CALIFORNIA INSTITUTE OF TECHNOLOGY		LIGO PROJECT	
DRWN	C. CONLEY	TYPE	BEAM TUBE BAFFLE, NON-SERRATED, FABRICATION AND PORCELAIN COVERAGE DETAIL
ENGR	A. SIBLEY	DRAWING NUMBER	D960046
APPD	A. LAZZARINI	SHEET	1
APPD	D. COYNE	REV	2
SCALE	NTS

CALIFORNIA INSTITUTE OF TECHNOLOGY MICHIGAN STATE UNIVERSITY		LIGO PROJECT	
DRWN: C. CONLEY	ENGR:	BEAM TUBE BAFFLE, NON-SERRATED, FABRICATION AND PORCELAIN COVERAGE DETAIL	
APPD:	TYPE:	DRAFTING NUMBER: D960046	SHEET REV: 2/2 B
SCALE: NTS

DETAIL B

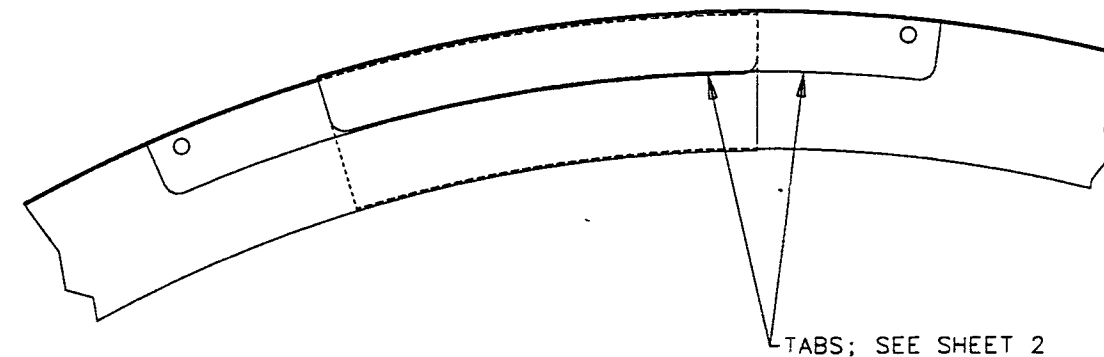
* TOP SURFACE OF CONE SEGMENT BUTT JOINTS TO BE FREE OF WELD MELT-THROUGH. EDGE MISMATCH NOT TO EXCEED .010 [.25].
 ALT 2 RATHER THAN 4 SEGMENTS.

TAB

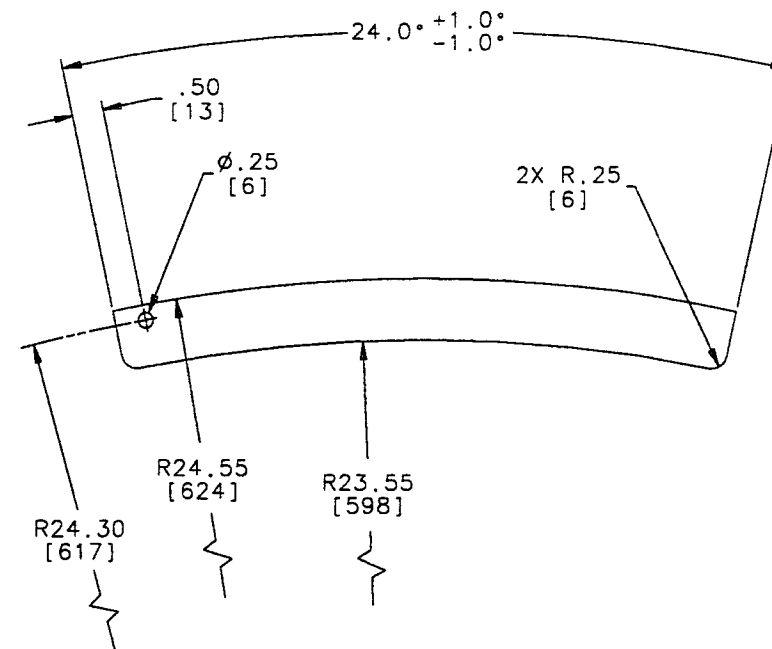
ALT METHOD TWO SECTIONS 109.2° EACH.

BAND

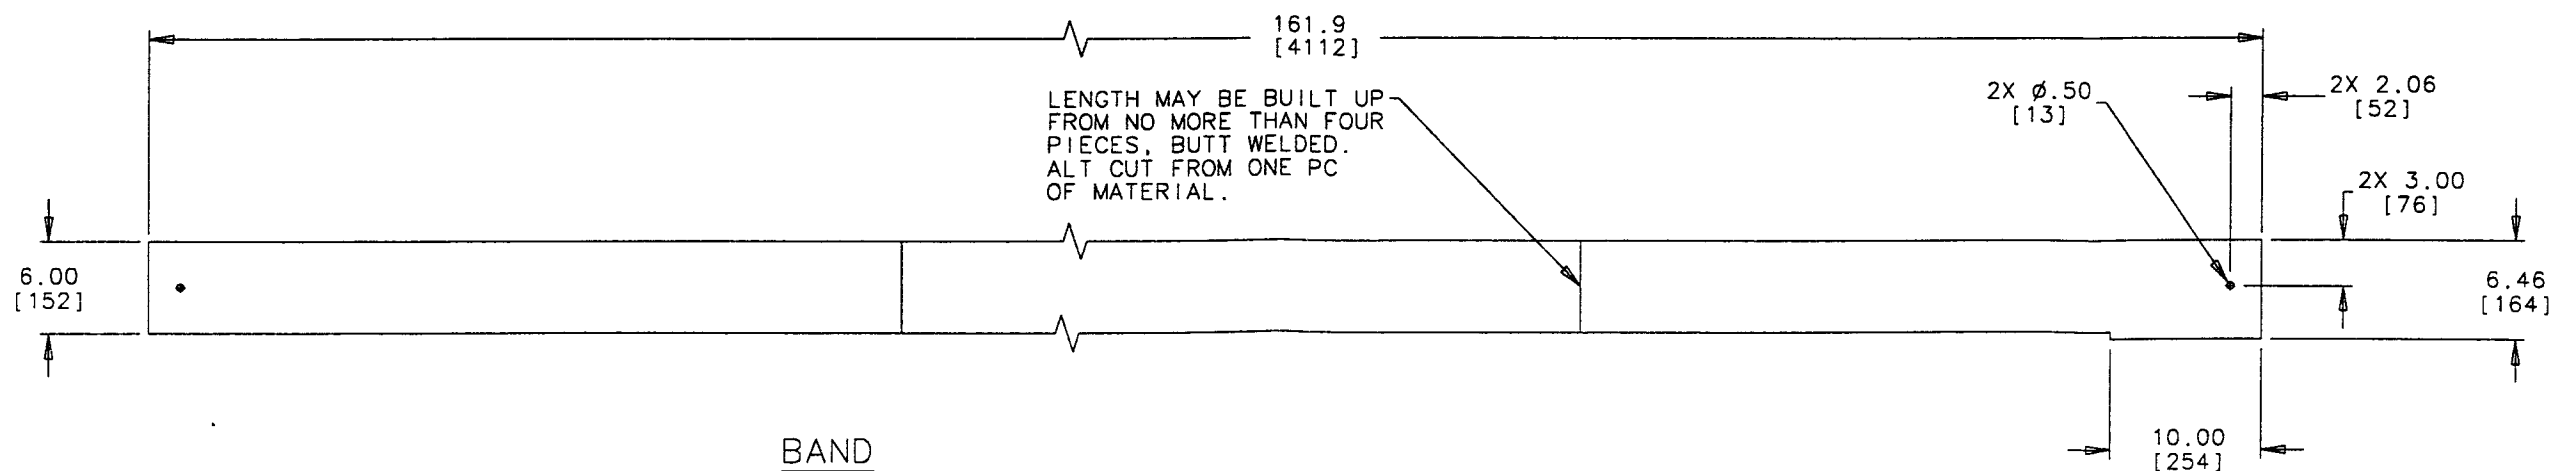
LENGTH MAY BE BUILT UP
FROM NO MORE THAN FOUR
PIECES, BUTT WELDED.
ALT CUT FROM ONE PC
OF MATERIAL.
